**Addendum No. 3**  
Page 1 of 21

Joliet Junior College  
1215 Houbolt Road  
Joliet, IL 60431

**TO:** Prospective Respondents  
**SUBJECT:** Addendum No. 3  
**PROJECT NAME:** Renaissance Center Interior Renovations  
**JJC PROJECT NO.:** B16008

**8 FAN SUPPORT DETAIL**

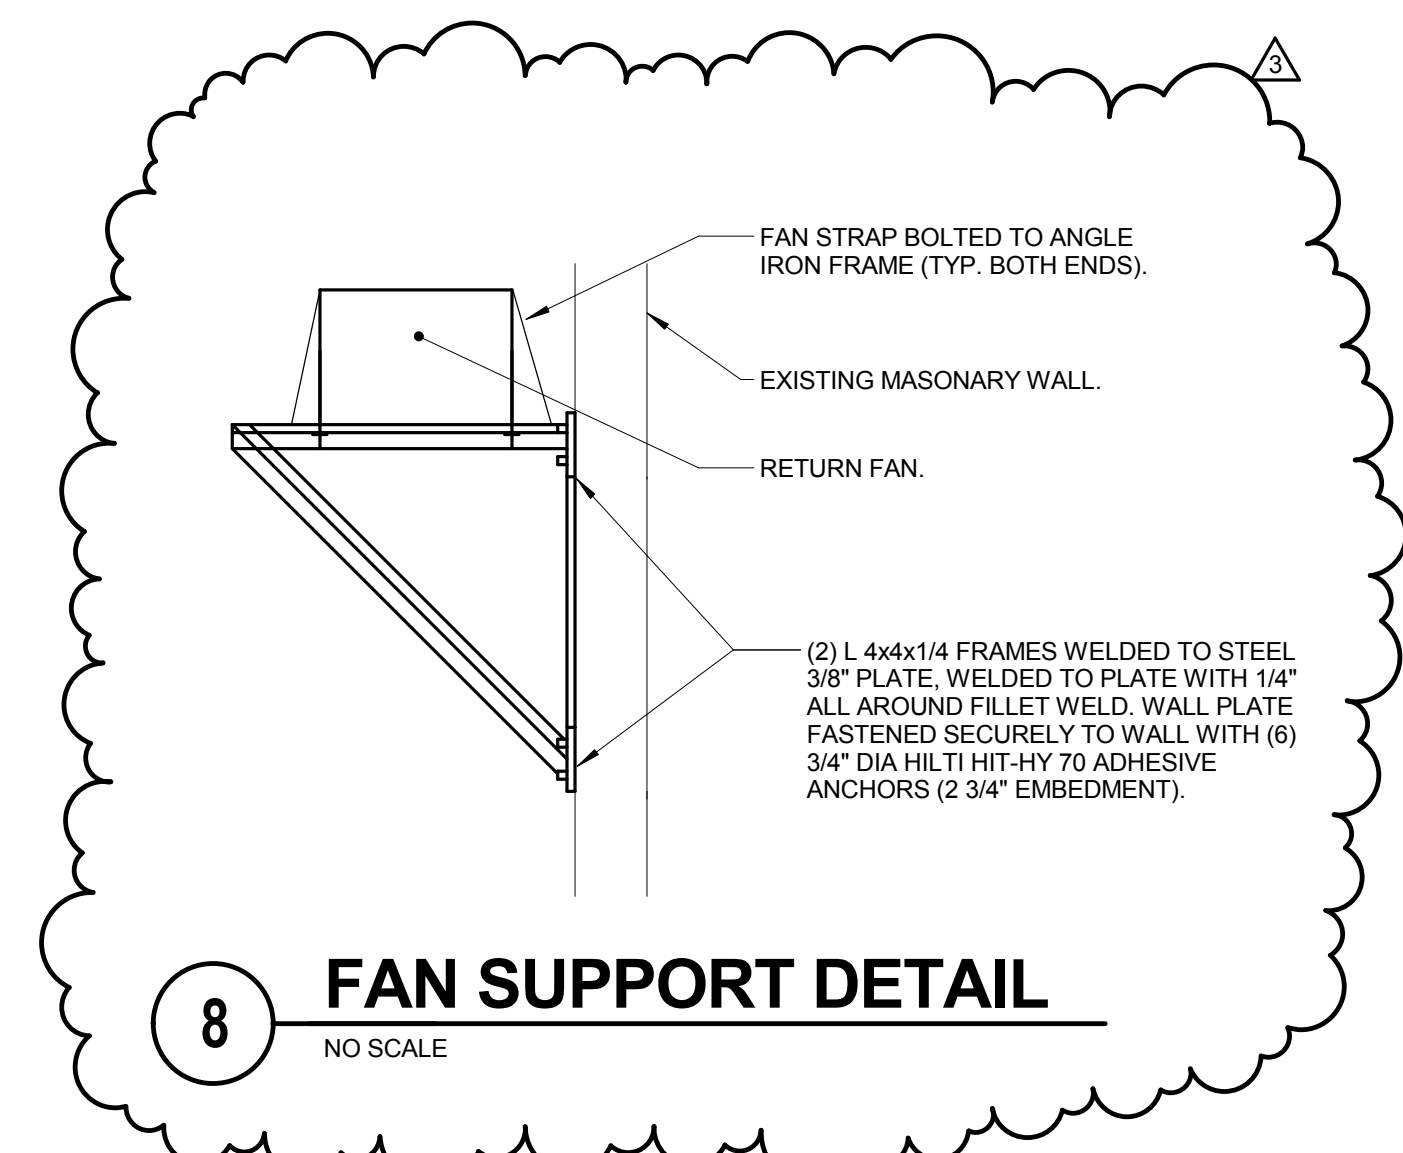
- E. Drawing M2.30: **Add** HC-1 and associated gas piping. **Modify** location of RTU-3 and CU-2. Refer to M2.30 for additional information.
- F. Drawing M3.01: **Add** Fan support detail as 8/M3.01. Refer to M3.01 for additional information.

SHEET NUMBER:  
**P2.00**

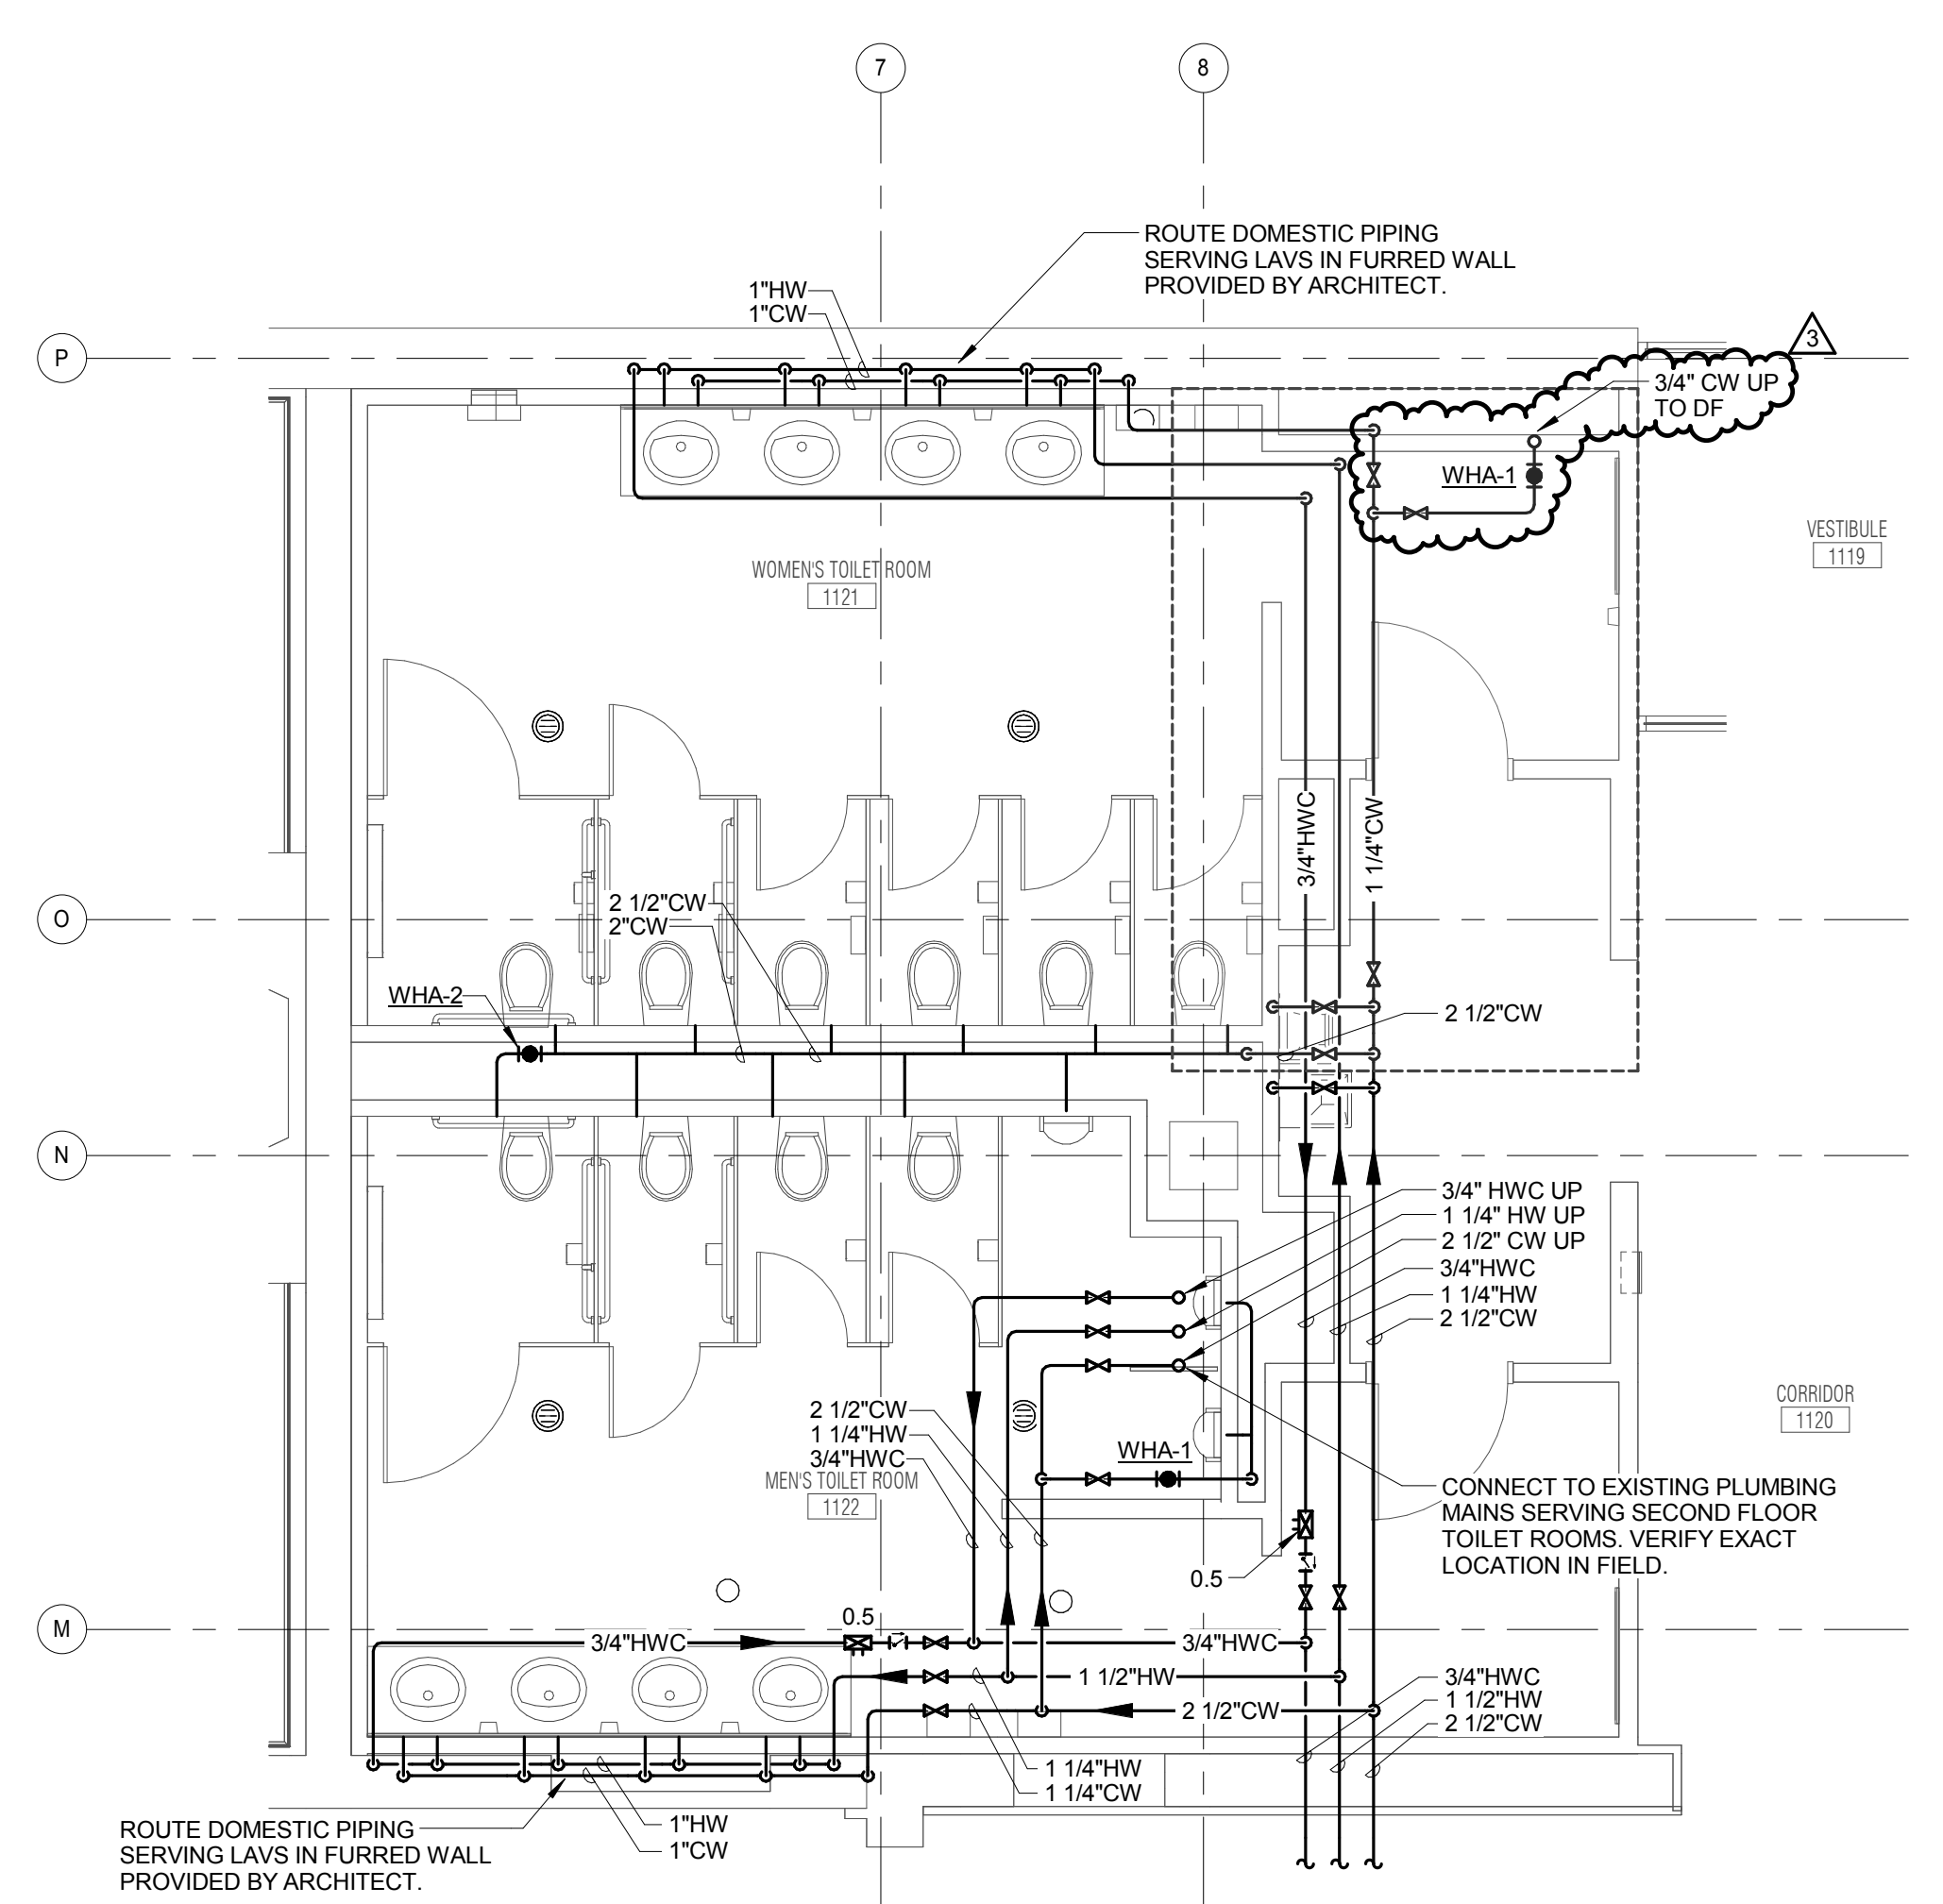
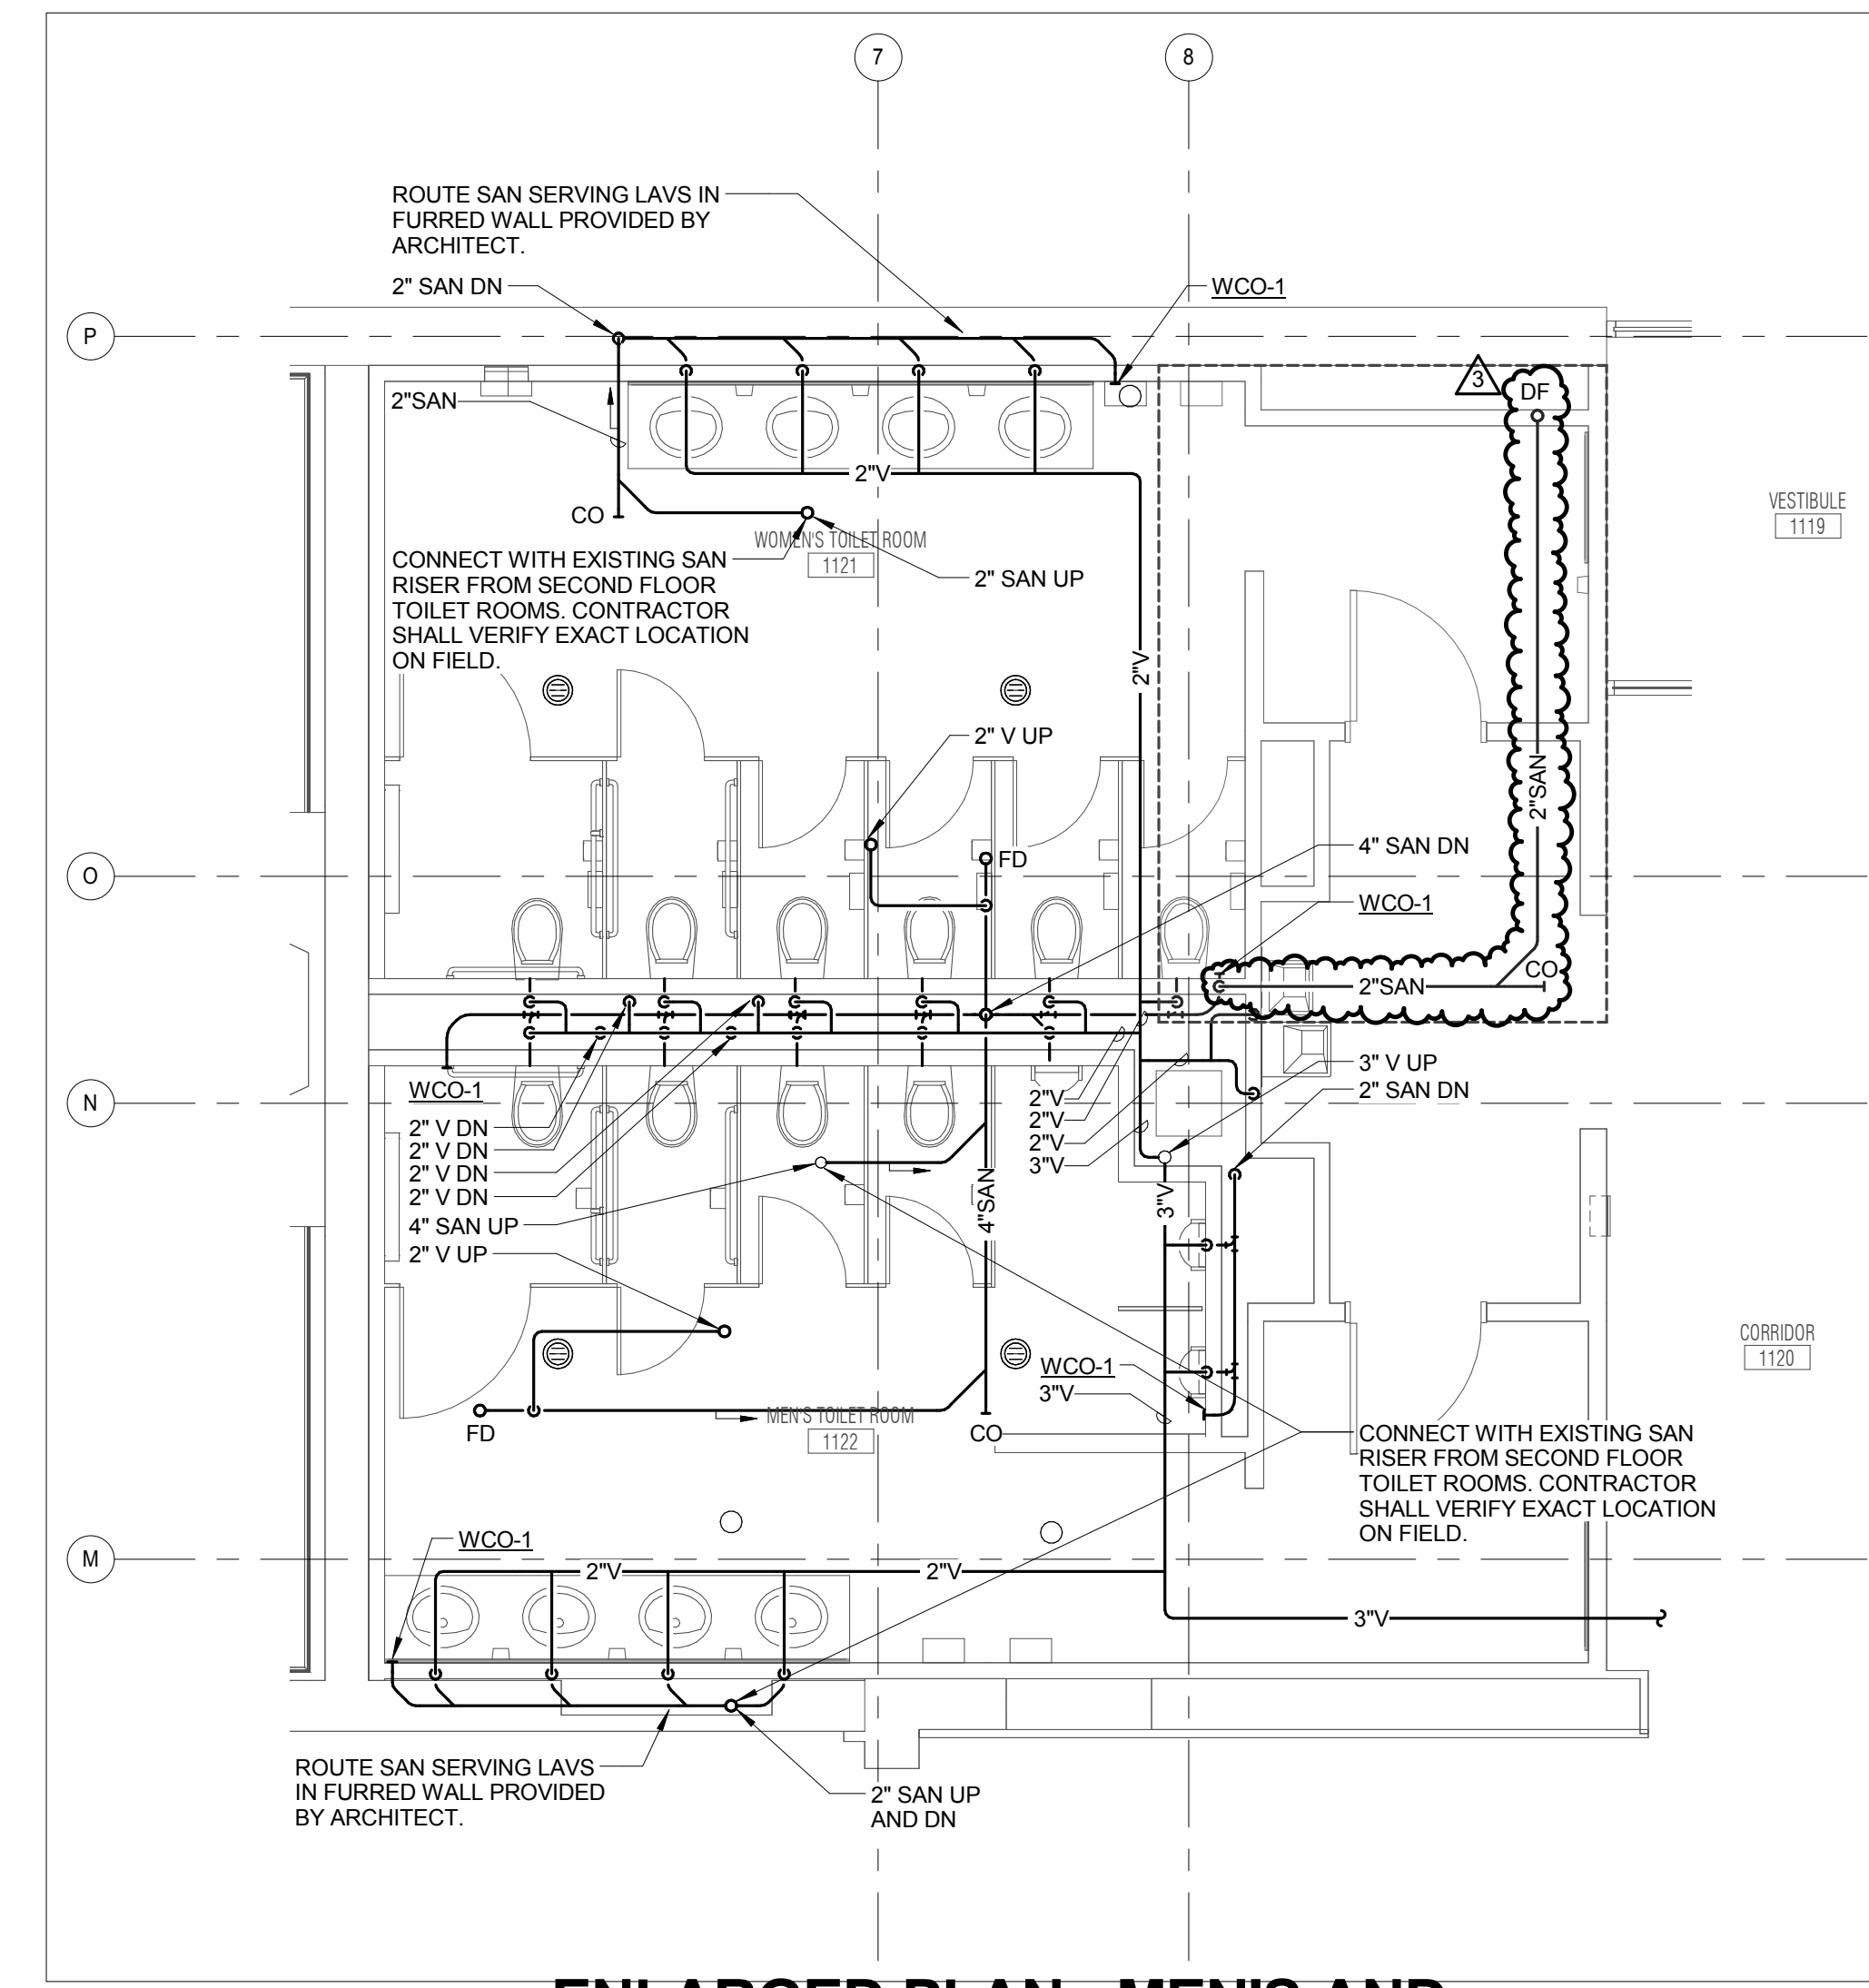
- D. Drawing P1.20: **Add** DF-1 to second floor Men's 2111. Tie vent piping into existing riser. Refer for P1.20 for additional Information.
- E. Drawing P2.00: **Modify** cw and sanitary piping within Men's 1122 as required to serve new DF-1 on second floor. Refer to P2.00 for additional information
